Access Compliance Report Public Rights-of-Way (Curb Ramps)

Intersection ID: 8739Main Street: N_TRYON_STCross Street: W_EASTWAY_DRLocation:NWADA ID: B6C3301B5DB5Ramp Type: ParaInitial Pass/Fail: FailOverall Compliance: NoSeverity Score:25

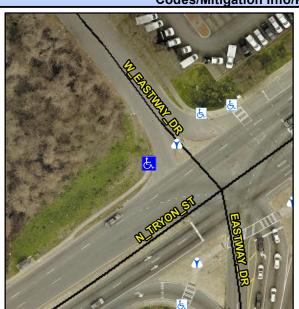
R304.3.2

Remove & Replace Entire Ramp.
